**RESPONSE TO
PLANNING
OBSERVATIONS**

**PROPOSED
REDEVELOPMENT**

**10 CHRISTCHURCH
HILL, HAMPSTEAD
LONDON NW3**

November 2014

Midwinter's Day

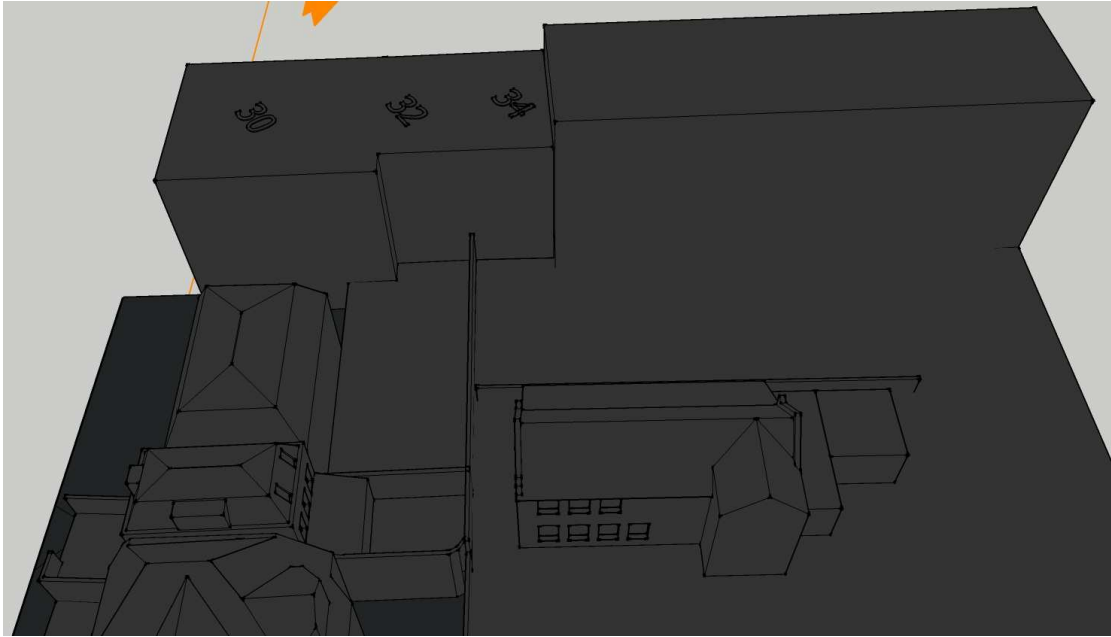
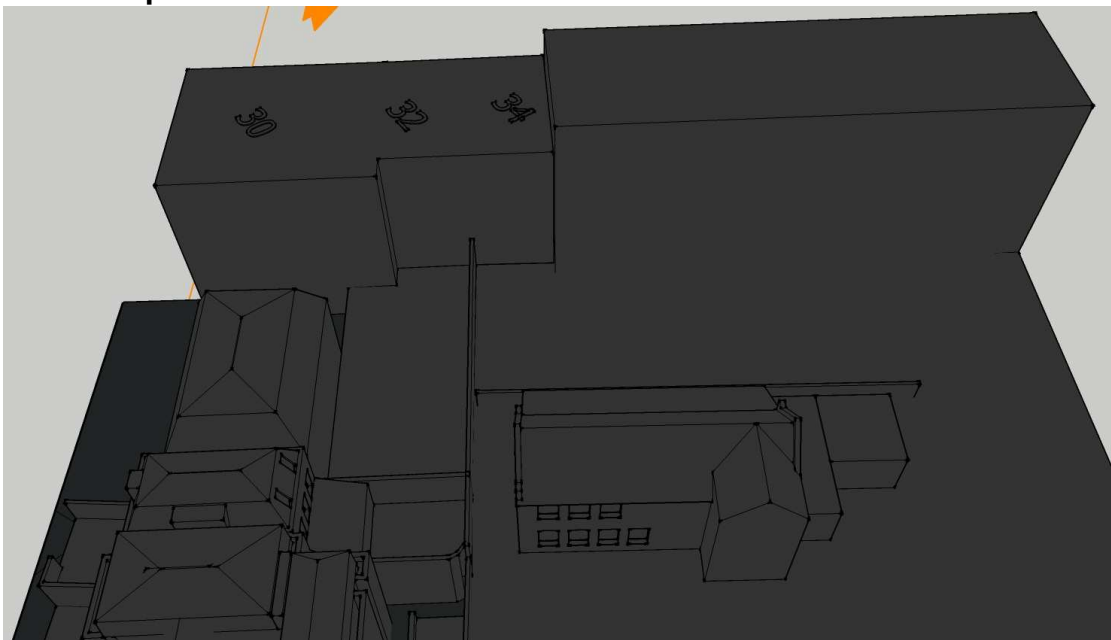
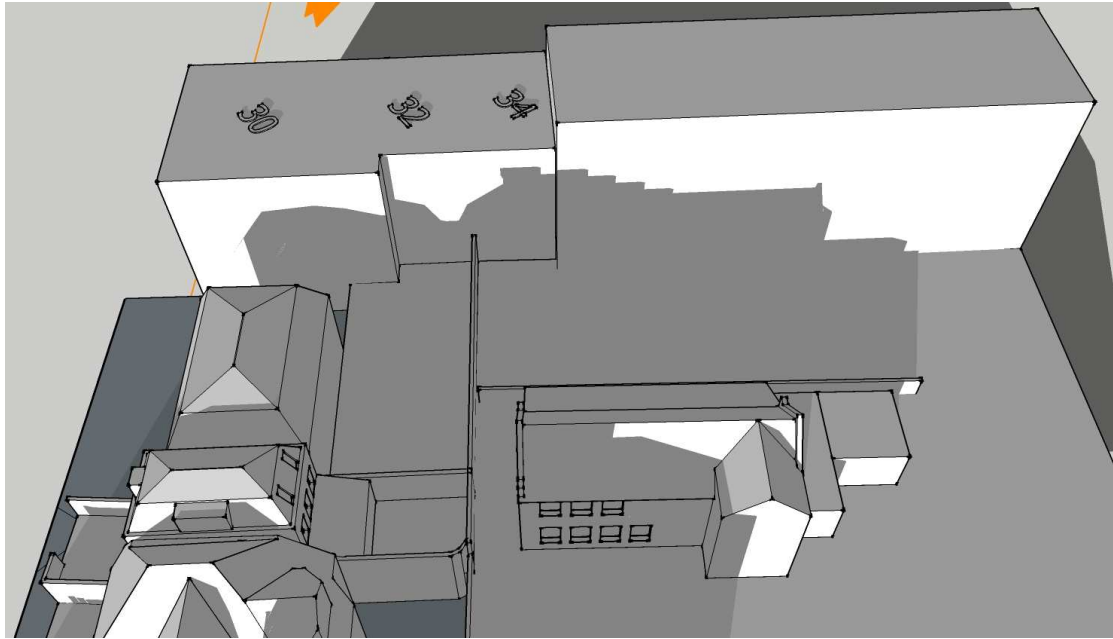
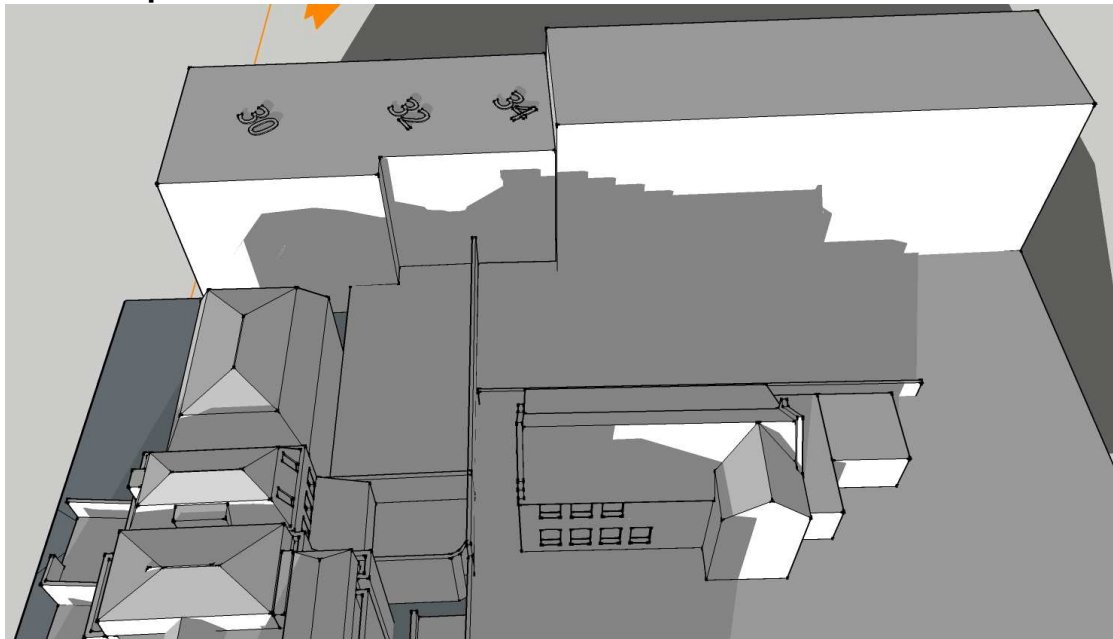
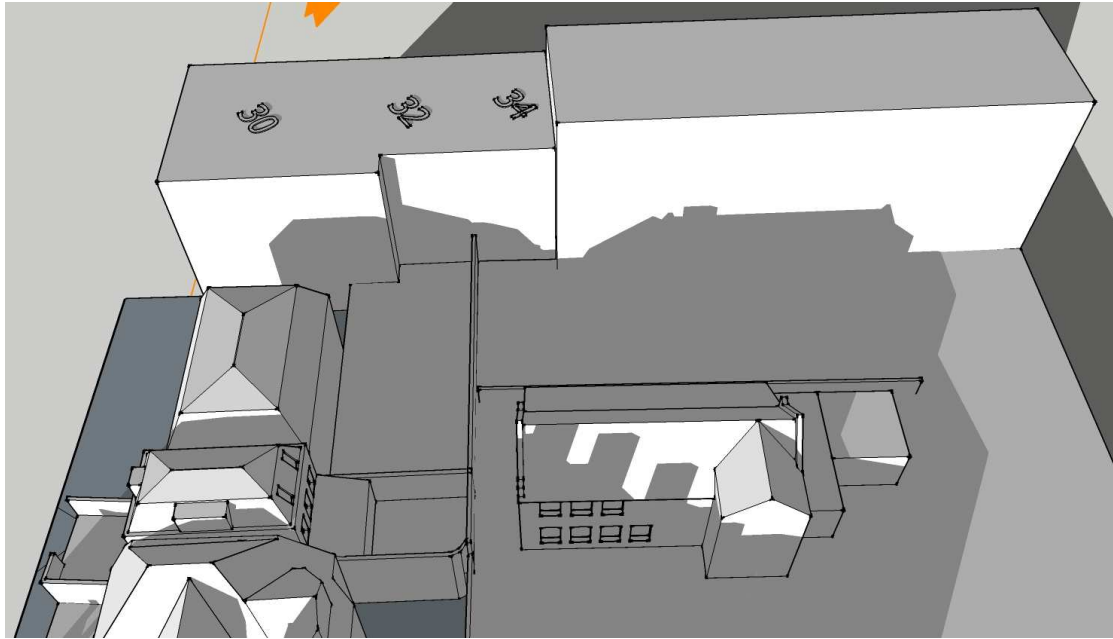
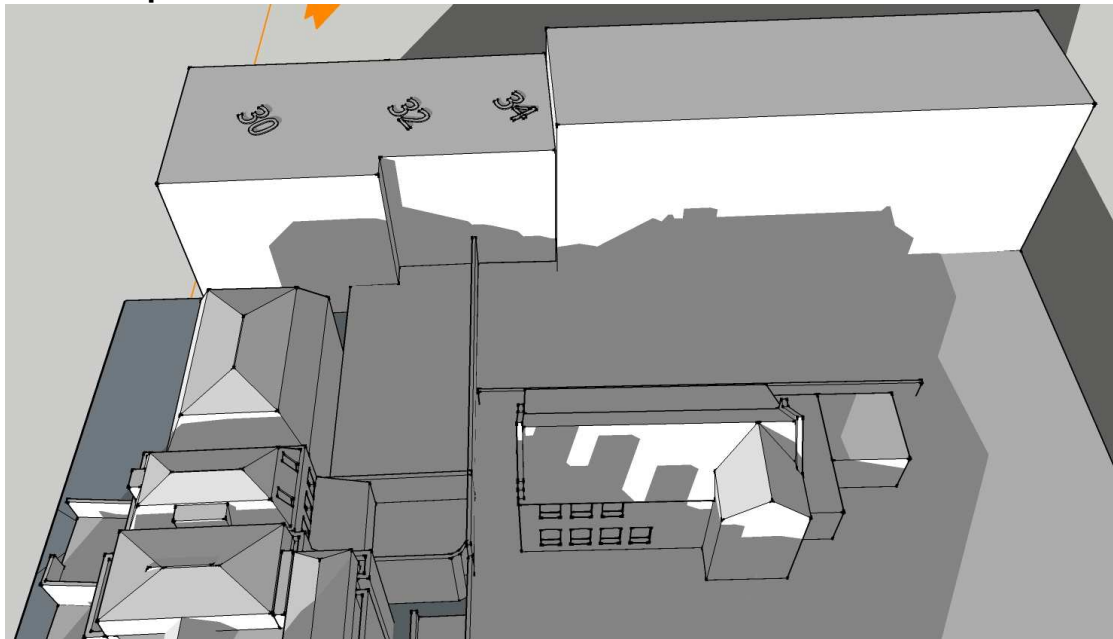
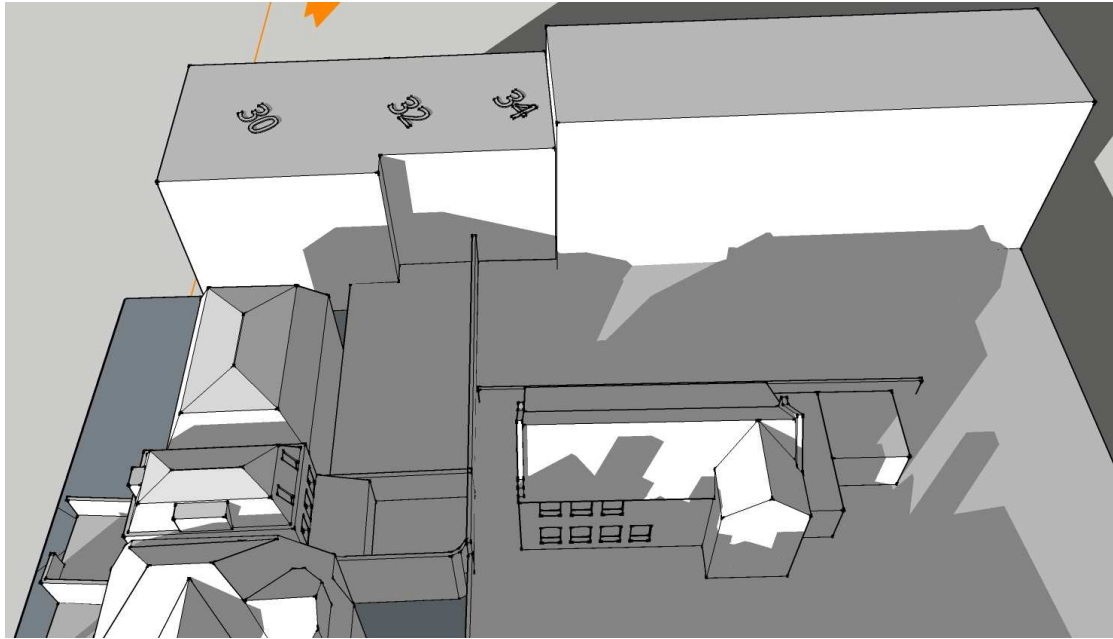
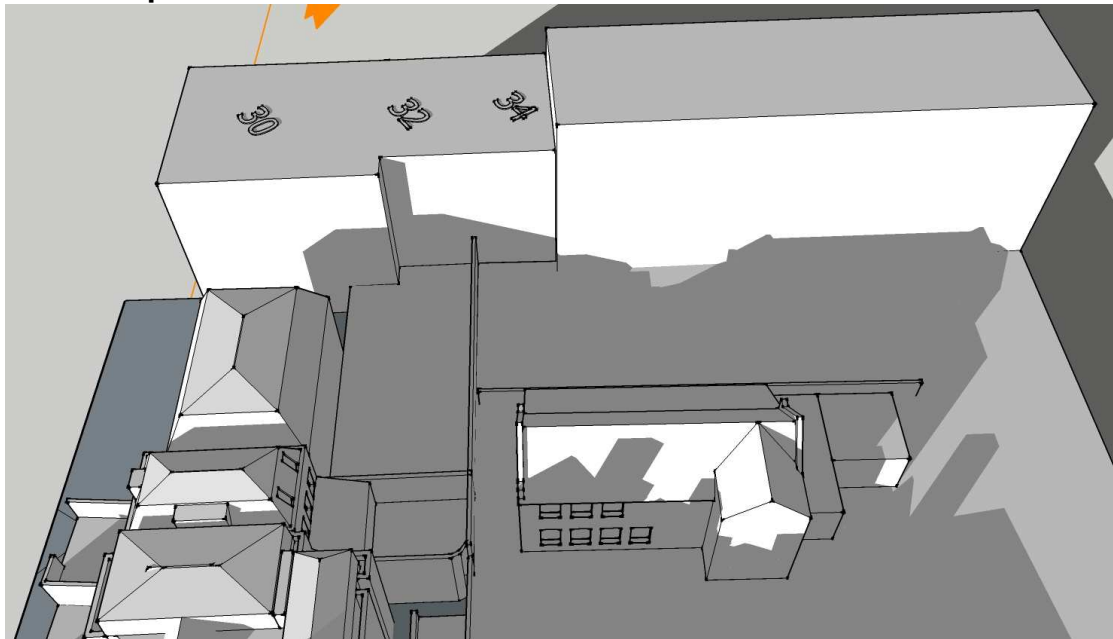
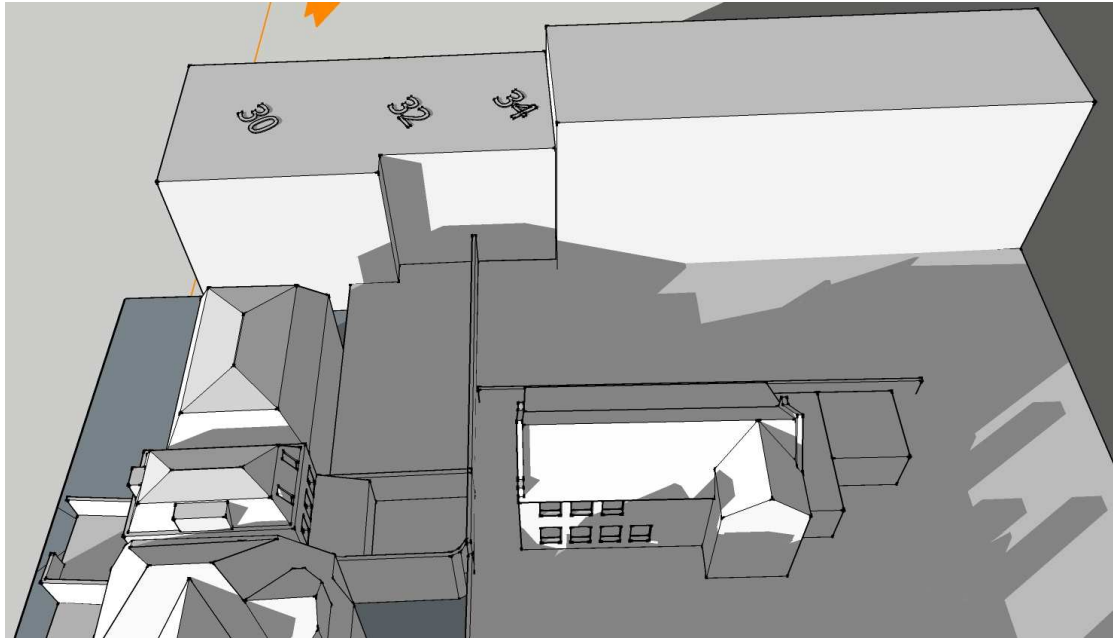
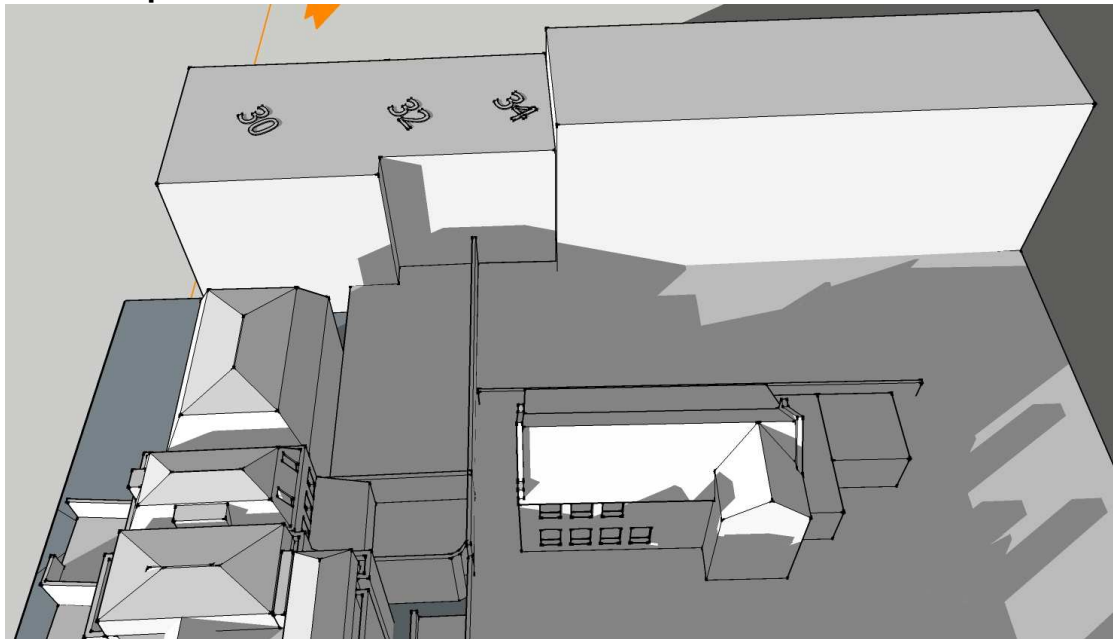
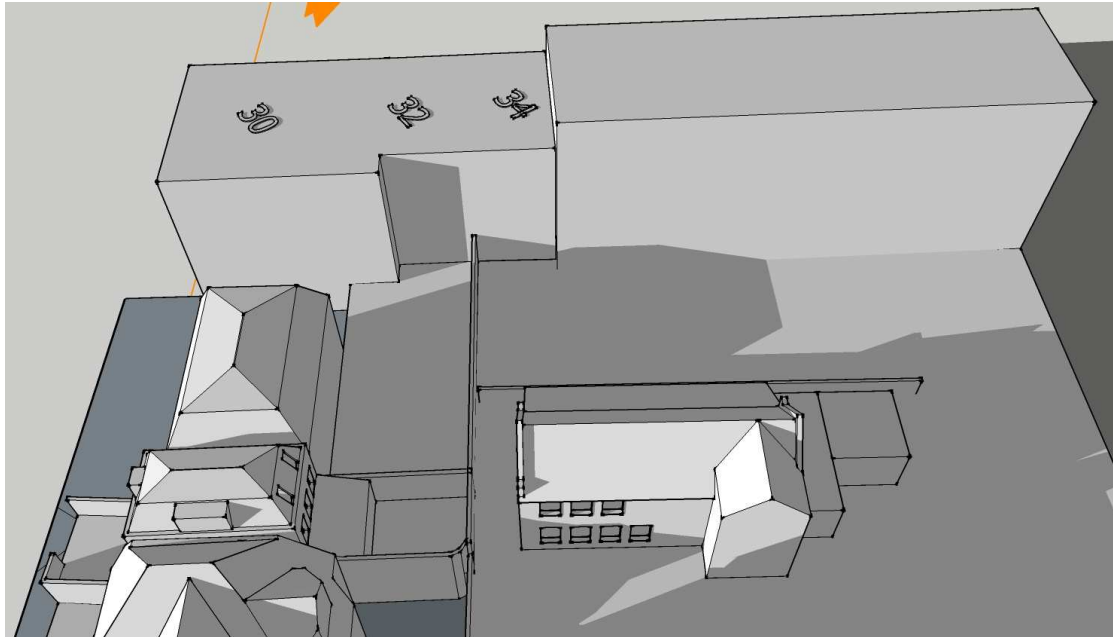
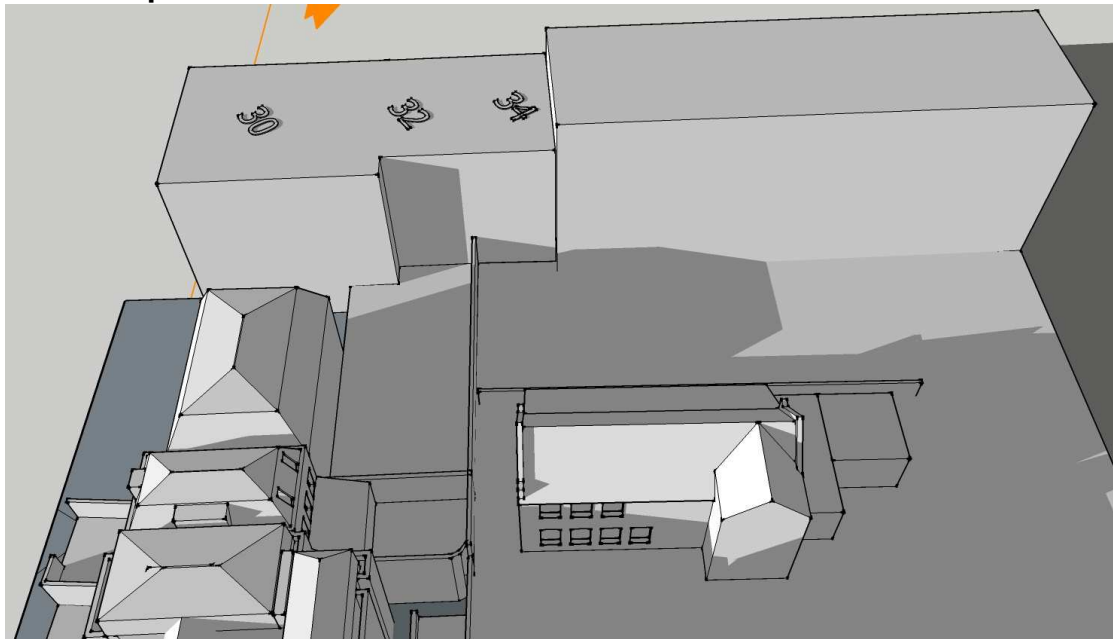
- The proposed development with its higher roofline which continues for a longer length (perpendicular to Christchurch Hill) and is also wider (parallel to Christchurch Hill), will impact the light at the back of 34 Well Walk, both in respect of the rear ground floor windows and also the patio, and will be especially acute during the Autumn to Spring months when the sun is lower and natural sun light is already somewhat limited. The Daylight & Sunlight Report submitted for this application is at a time of year which seems to drastically underestimate the effect of the proposed building given the sun is much higher in the sky in the period analysed vs. the Autumn to Spring months.
- The proposals will impact on light levels on the front gardens of nos. 13 and 14 Gainsborough Gardens and the rear gardens of 11, 12 and 13 of the same street.

As regards 34 Well Walk, it is averred that our analysis was made at an adjusted time of year to improve the apparent effects on the rear of this building and “to drastically underestimate the effect of the proposed building”. This is not the case as the initial shadow diagrams were compiled for the Equinox (21st March and 21 September). In response to this allegation, however, we have compiled proposed and existing analyses of the situation at the rear of 34 Well Walk at hourly rather than two-hourly intervals and at the Equinox, Midsummer’s Day (21st June) and Midwinter’s Day (21st December). These are set out below.

As can be seen from these images, there is no effect whatever on the sunshine reaching the rear of 34 Well Walk or its patio caused by the proposals on either Equinox nor Midwinter’s Day nor Midsummer’s Day. The assertion made is, therefore, without any foundation whatever and our original report does not underestimate the effects, drastically or otherwise, of the proposed building.
